In the Matter of AmerGen Energy Co, LLC
Docket No. 50-0219-42 Official Exhibit No. Exh. 12
OFFERED by: Applicant/Licensee Intervenor
NRC Staff 9/20/07 Other _____
IDENTIFIED on Kaufman Witness Panel N/A
Action Taken: ADMITTED REJECTED WITHDRAWN
Reporter/Clerk DW

MEMORANDUM

Subject: **Update of Current Knowledge Regarding the State of Integrity of OCNGS Drywell Liner and Comments Pertaining to Aging Management Thereof**

Figure 2

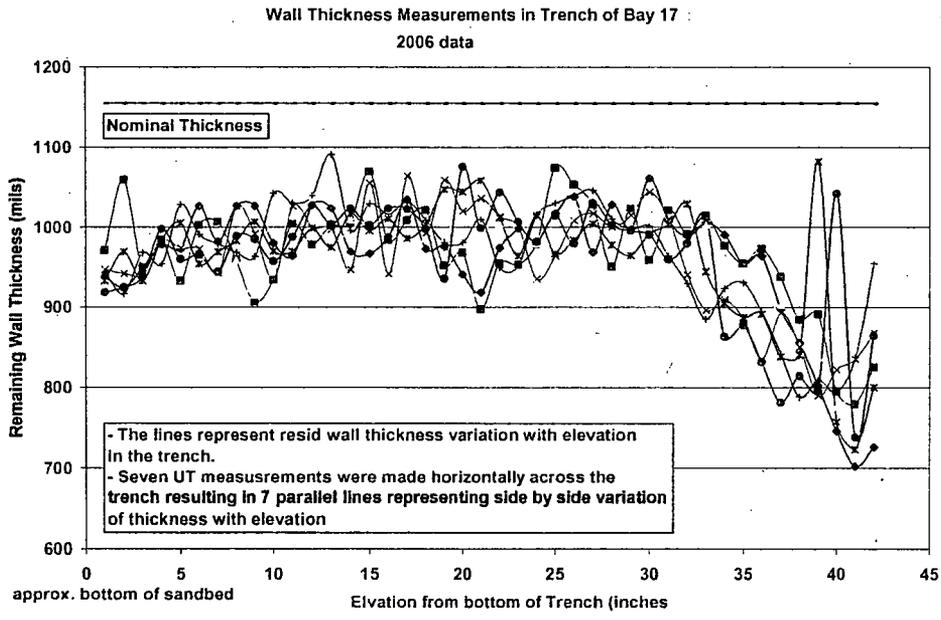
We take issue with this statement. In support of this contention, an effort was made to show graphically the remaining wall thickness observed in all of these various locations. Thus Figure 2 shows, by way of example, the remaining wall thickness from the 2006 UT measurements made with the help of 6 by 6 inch grids as a function of elevation in the **trench of Bay 17**. It is understood, as is described in Ref. 3 that 6 such grids were placed one on top of the other in the trench in order to capture the corrosion from the bottom to the top of the sandbed. Hence, if the bottom of the trench had the elevation about 9 feet, then the top of the 6 grids would have had an elevation of about 12 feet, which according to Figure 1 corresponds to the top of the sandbed and is at least 9 inches higher than the top of the grid used for UT measurements from the inside. (Note, none of these elevations is terribly accurate, however, the top of the trench measurements were definitely lower (deeper pits) by a good margin than the inside grid measurements). Figure 2 plots all individual 2006 measurements from the trench in bay 17. The 6 traces represent the variation of the wall thickness in the horizontal direction while the traces themselves extend from the bottom of the trench (left hand side) to the top of the trench (right hand side). The

undulations of the 6 traces, which are at times (at the same elevation) in synch and at other times out of phase clearly depict the nature of the “golf ball type” surface described in AmerGen literature (Ref. 1 pg. 4). Where the undulations are in synch one can estimate that the extent of the pit at that location extends over an area larger than just one inch in diameter³⁾. It should also be noted that the average amplitude of the undulations in Fig. 2 are of the order of 0.1 inch, i.e. the roughness of the surface at this point is only of that order of magnitude. AmerGen estimated the “roughness” of the surface to be rather of the order of 0.2 inches (Ref. 5 pg. 5).

The most striking observation is that the corrosion is most severe at the top, almost uniform in severity over most of the depth of the sandbed and again somewhat more severe at the very bottom.

Figure 3

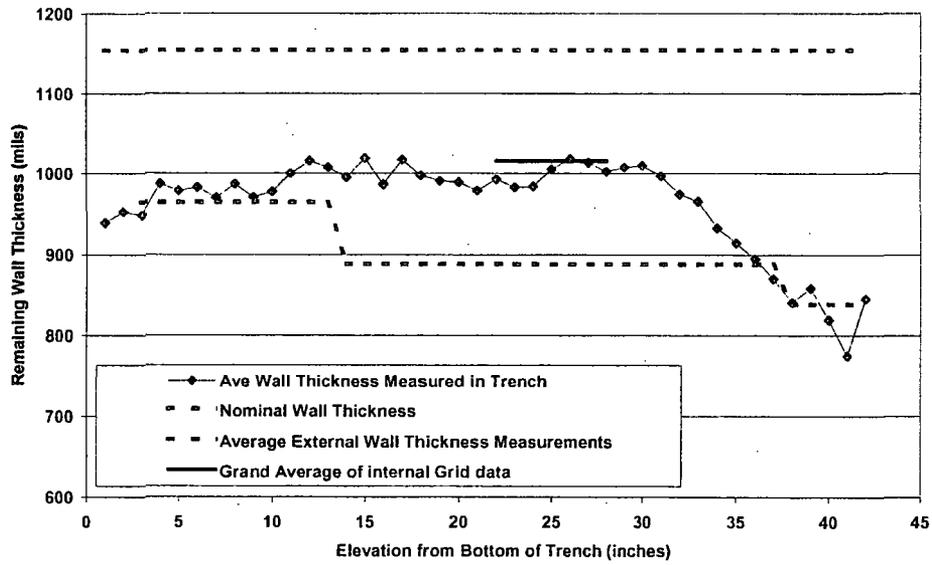
In Figure 3 an effort is being made to compare the average remaining wall thickness from trench measurements (averaged over the horizontal direction) with the average of the 6 by 6 grid measurement from the inside and the direct UT measurements from the outside. Also graphed in this figure are the averages of the outside measurements for the three zones for which data are reported (Ref. 5). What one can see is that the averages for the grid and the trench data overlap quite well at the same elevation. However, the average outside measurements are significantly lower at comparable elevations.⁴⁾ This is probably because the choice of location for the external measurements was deliberately biased towards thin spots.

Figure 4

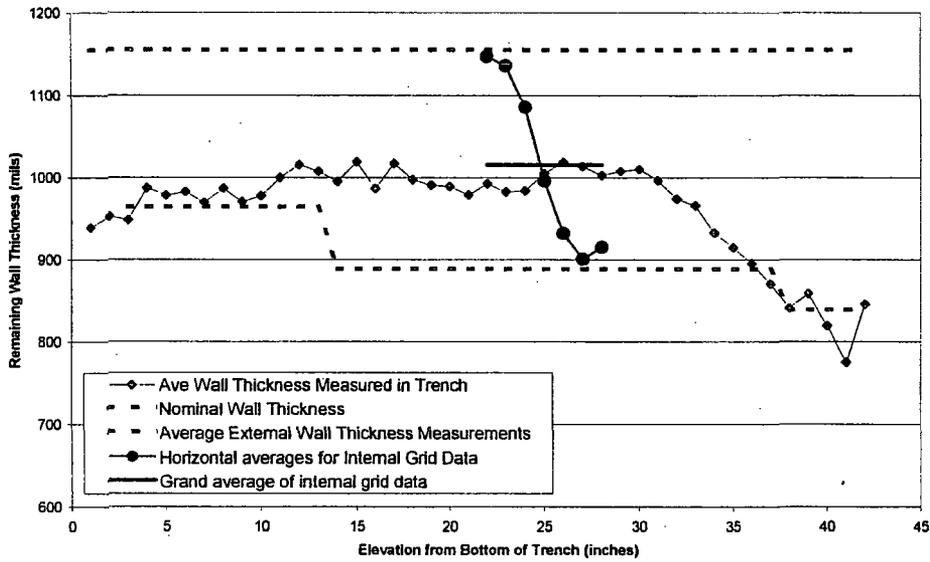
Finally in Figure 4 we see the spread of the 6 by 6 inch inside grid measurements superimposed on the averages of the other measurements.

Conclusion: What the superposition of the UT measurements in Bay 17 demonstrates is that wall loss ranges from zero to 33 percent, however, only the trench and outside measurements come close to represent the most severe corrosion at the highest elevations. It should also be remembered that the grid measurements at the inside curb cutout as well as those in the trench are only 6 inches wide. One does not have, therefore any indications as to how far serious corrosion may have spread laterally around the circumference of the bay.

Figure 5

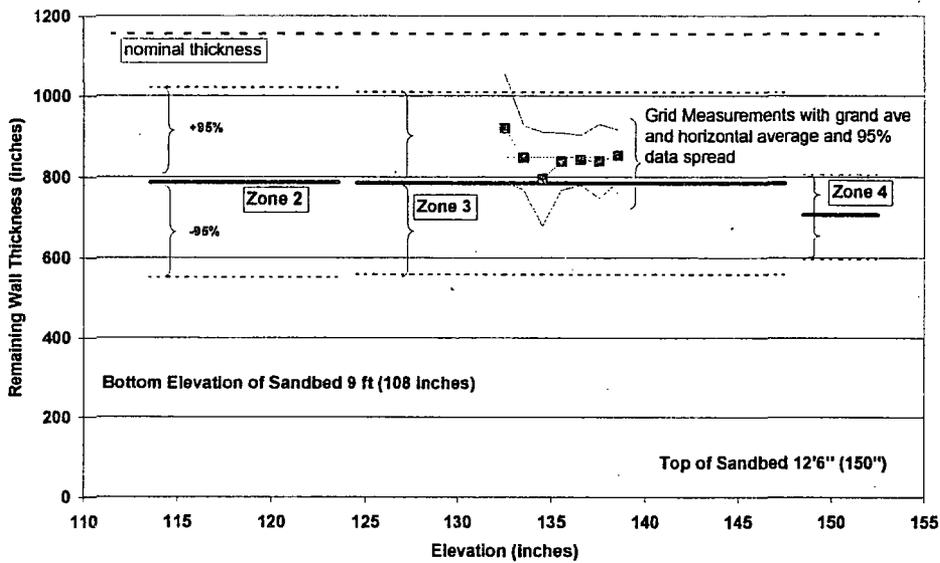
Figure 5 shows an analysis of the available 2006 data for Bay 13. Bay 13 is probably the second worst corroded bay apart from Bay 1. The averages for the external measurements for each zone are fairly similar, as are the 95% limits for the data spread. There is a 95% percent probability for the deepest penetration to be of the order of 48% of the original wall thickness. The superposition of the internal grid data shows a higher average and a narrower distribution of the data spread. Again one recognizes that the internal 6 by 6 inch grid measurements do not represent the worst corrosion degradation.

Figure 6

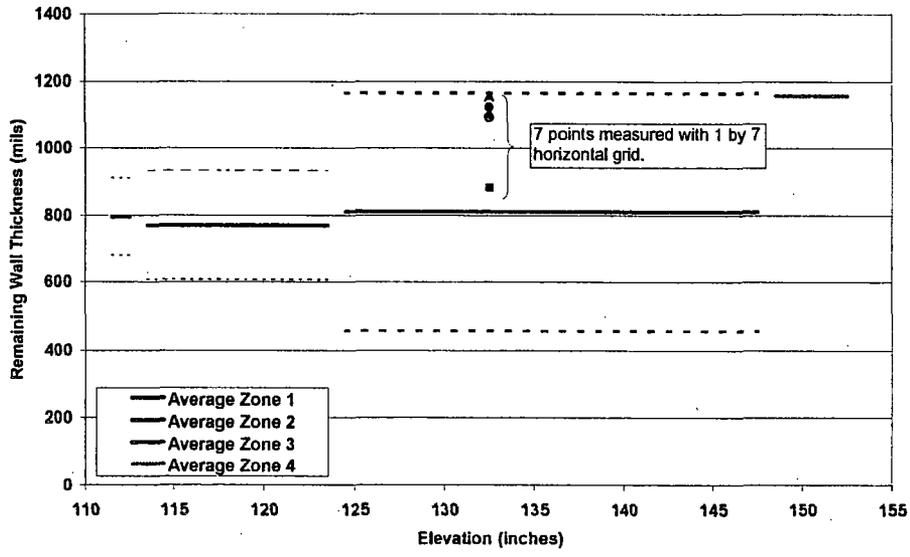
Finally in Figure 6 we show the distribution of the external measurements for Bay 1. One observes that the 95% lower limit of the data spread is around 40% of the original wall thickness, or indeed at a remaining wall thickness of 450 mils, which is 0.04 inches below the required sandbed thickness for the Design Pressure and Temperature. Because the external sampling in Bay 1 was designed to capture the thinnest points, this is a conservative estimate of the minimum wall thickness. However, given the need for a very high degree of confidence that the drywell shell is ready to withstand accident pressures and the uncertainty created by the sparse data set, I believe that a conservative approach is required in this case.

Figure 7

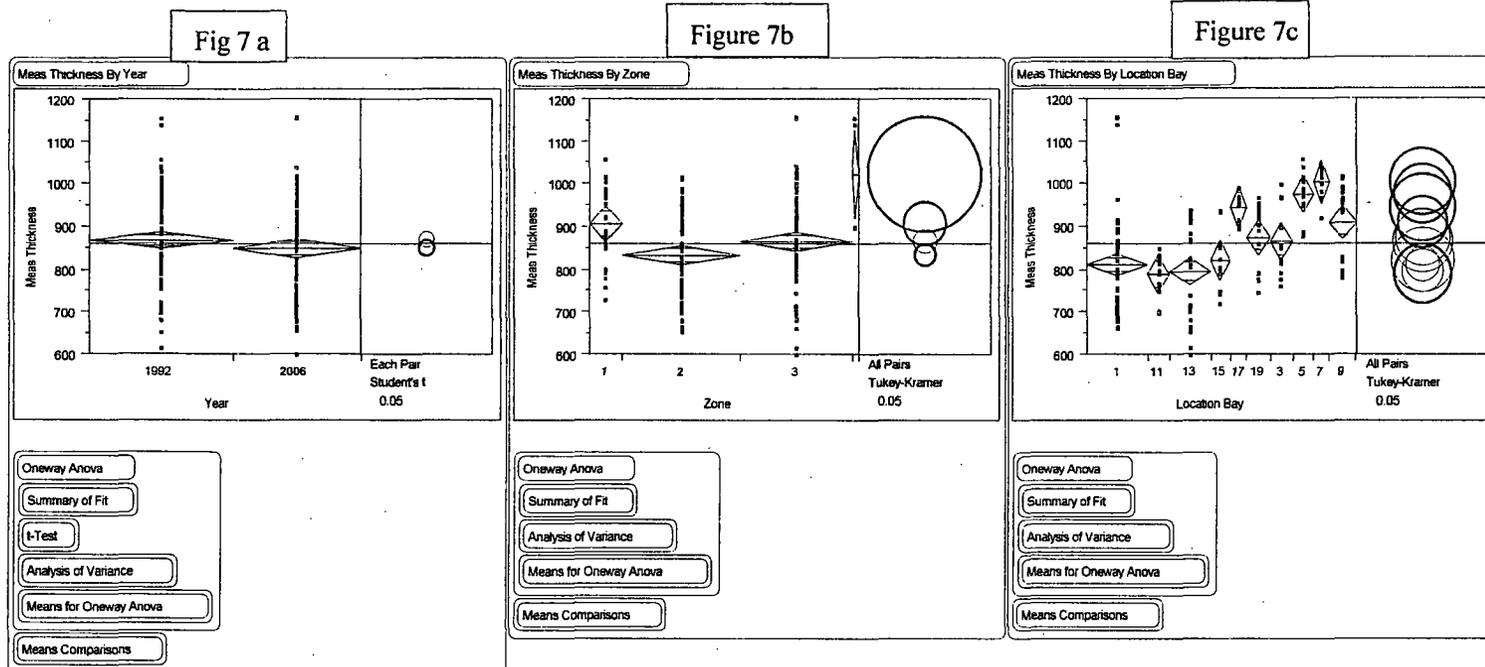
It was found that there is no significant effect of the time (Fig.7a). While there is a decrease of 19 mils between 1992 and 2006, this difference is not statistically significant within the variability of the data. The differences between the zones, however are significant. Zone 2 is by far the most corrosive zone. When the bays are compared, one finds as expected that some bays have experienced little corrosion in contrast to others. The importance of these observations is obvious: they point again to the fact that the intensity of corrosion is a clear function of elevation and bay. Hence, averaging data and generalization may lead to doubtful conclusions.

Figure 7a: Comparison between measurements I 1992 and 2006 show no significant difference. The means from 1992 and 2006 show a bias of 0.018 inches, but the bias is statistically not significant despite of the many data points. Fig. 7b: The comparison between the "zones" (elevations) is significant. Zones 1 is significantly different from zones 2 and 3. For zone 4 there are not enough data for statistical significance. Fig. 7c: Some bays, red ones, are significantly different from the black ones.

Figure 8: External UT Measurements in Bay 15

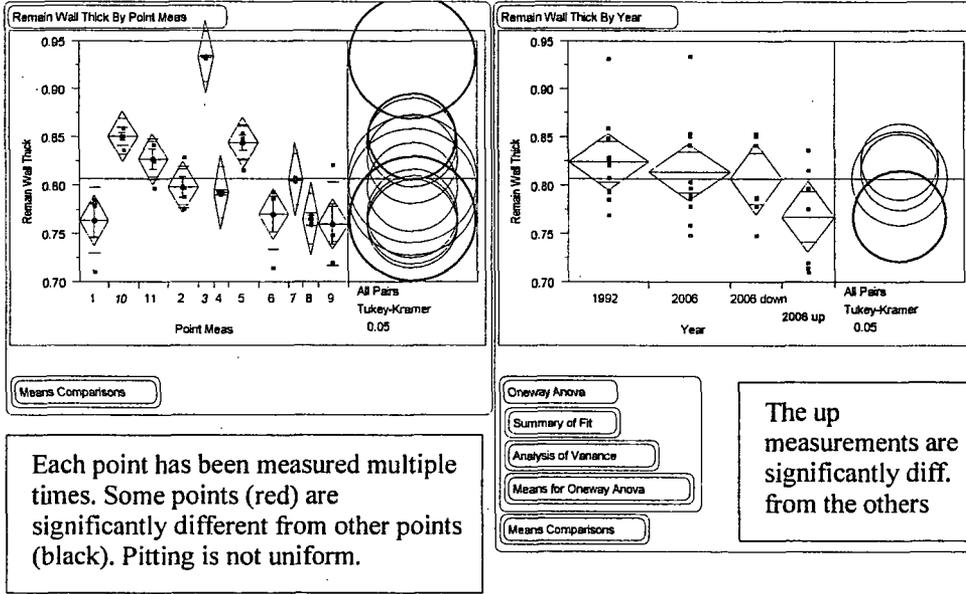
In 2006 the validity of some of the external UT measurements was explored by measuring around the nominal original locations. These data were statistically evaluated in Figures 8, 9, 10 for Bays 15, 1 and Bay 19. The additional data collected in Bays 19 and 15 had been identified as “up” or “down”, hence additional data sets

identified as 2006 up and 2006 down were compared with the original 2006 data. It turns out for Bay 19 for instance that the UT penetrations identified as 2006 up were significantly lower than the measurements of 1992 with a probability of better than 95%. The difference between the 1992 and 2006 up data is 0.1 inch. Similarly for Bay 15 one finds that the 2006 up data are significantly lower than the original 1992 data by about 0.06 inches, although this difference is not significant at the 5% level. For Bay 1 there is practically no difference between the 2006 and the 1992 data sets, because of the two or three measurements in the non-corroded areas. Summarizing these results in Table 1, one finds that the lower 95% confidence limits for Bays 1, 15 are marginally within the 0.736-inch limit. Since one does not know exactly how extensive the "cancer of corrosion" in the sand bed area really is, it is very difficult to put this interpretation in perspective with the assessments made by AmerGen relative to areal criteria for thinned areas (see discussion below).

Figure 10: External UT measurements in Bay 19

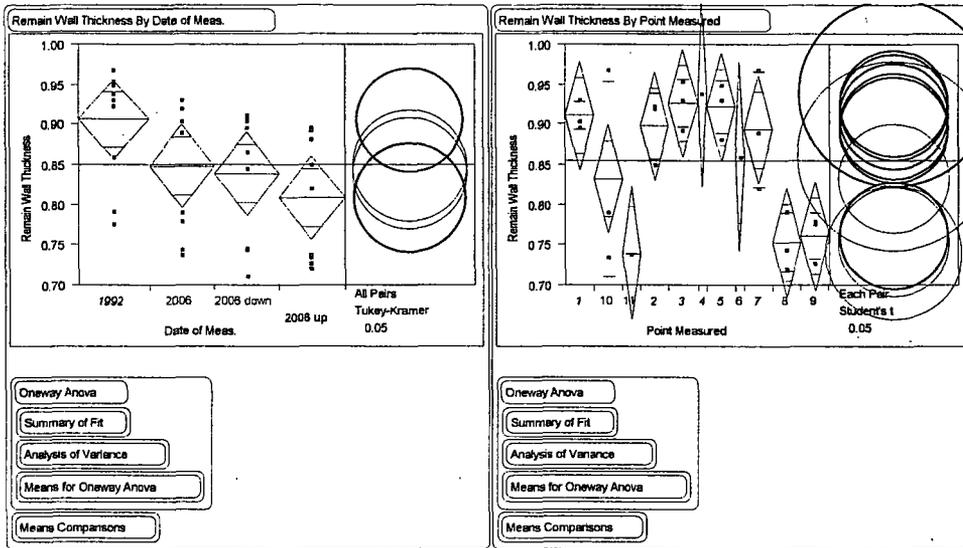
Again one finds that the “up” measurements are significantly lower from the 1992 measurements.
